# Access Compliance Report

## Public Rights-of-Way

Intersection ID: 43357	Main Street: PROSPERITY_VIEW_DR	Cross Street: WOODLAND_COMMONS_DR	Location:	N
ADA ID: 22B6F9A1567A	Ramp Type: PerpDiag	Initial Pass/Fail: Fail	Overall Compliance: No	Severity Score: 10

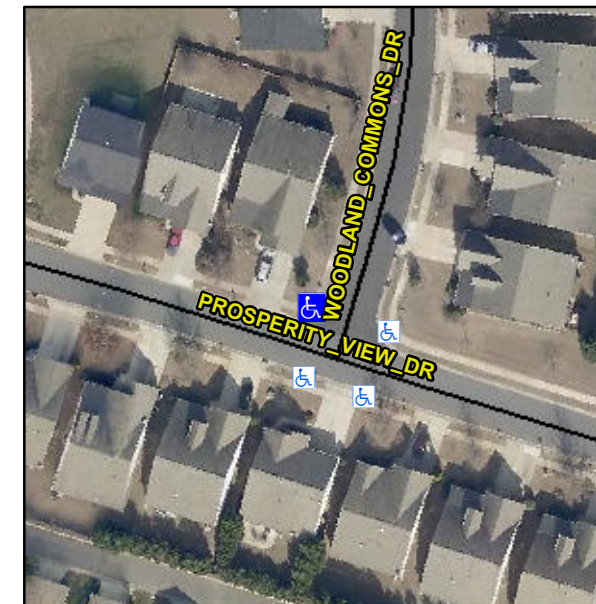
**Not Found, R304.5.1, R304.5.3**

Compliance	Description	Data	Compliance	Description	Data
N/A	Ramp Length (in)	48.0	Yes	Ramp Slope (%)	7.6
No	Ramp Width (in)	42.0	No	Ramp XSlope (%)	4.7
N/A	Flare Type LT	N/A	N/A	Flare Type RT	N/A
N/A	Flare Slope LT (%)	N/A	N/A	Flare Slope RT (%)	N/A
N/A	Flare Traversable LT?	N/A	N/A	Flare Traversable RT?	N/A
N/A	Landing Length (in)	N/A	N/A	DWS Provided?	N/A
N/A	Landing Width (in)	N/A	N/A	DWS Contrast?	N/A
N/A	Landing Slope (%)	N/A	N/A	DWS Length (in)	N/A
N/A	Landing X Slope (%)	N/A	N/A	DWS Full Width?	N/A
N/A	Landing Curb? (Y/N)	N/A	N/A	DWS Offset (in)	N/A
N/A	Shared Landing?	N/A			
N/A	Gutter Ponding?	N/A	N/A	Gutter Slope (%)	N/A
N/A	Gutter Lip Ht (in)	N/A	N/A	Gutter X Slope (%)	N/A
N/A	Painted X Walk1?	No	N/A	Painted X Walk2?	No
	X Walk 1 Direction	To SW		X Walk 2 Direction	To SE
N/A	X Walk 1 Width (in)	N/A	N/A	X Walk 2 Width (in)	N/A
	X Walk 1 Slope (%)	2.9		X Walk 2 Slope (%)	0.6
	X Walk 1 X Slope (%)	2.1		X Walk 2 X Slope (%)	1.6

**Remove & Replace Curb Ramp With Two New Directional Ramps or Equivalent.**
